Campaign No. 2011010001, March 2011

SUBJECT: **Model 906, Model Year 2010**  
**Replace A-Pillar Trim**

**Procedure****Figure 1**

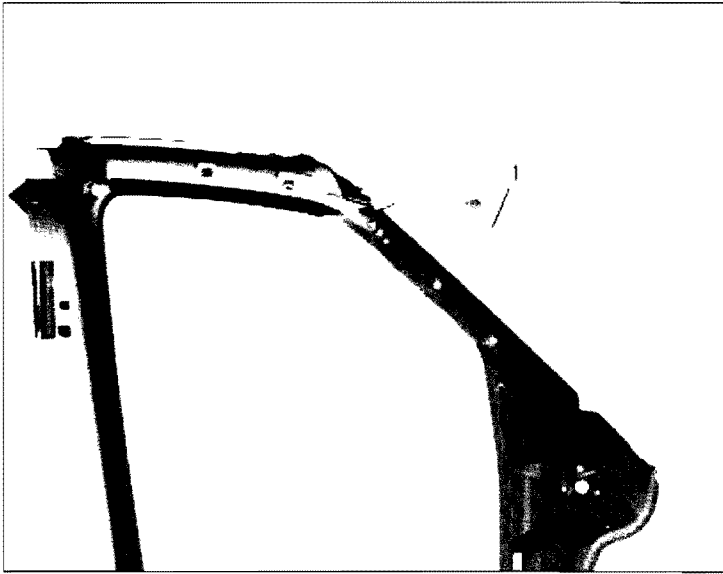
Daimler AG (DAG), the manufacturer of Mercedes-Benz and Freightliner Sprinter vehicles, has determined that due to documentation error the A-Pillar Trim installed in the vehicle may not be the correct one required for compliance with Federal Motor Vehicle Safety Standard (FMVSS) 201 (Head Impact Protection). Dealers will replace the A-Pillar Trim to insure compliance with FMVSS 201.

1. Remove A-pillar trim (1, Figure 1) from A-pillar.
2. Install new A-pillar trim (1, Figure 1) in reverse order.
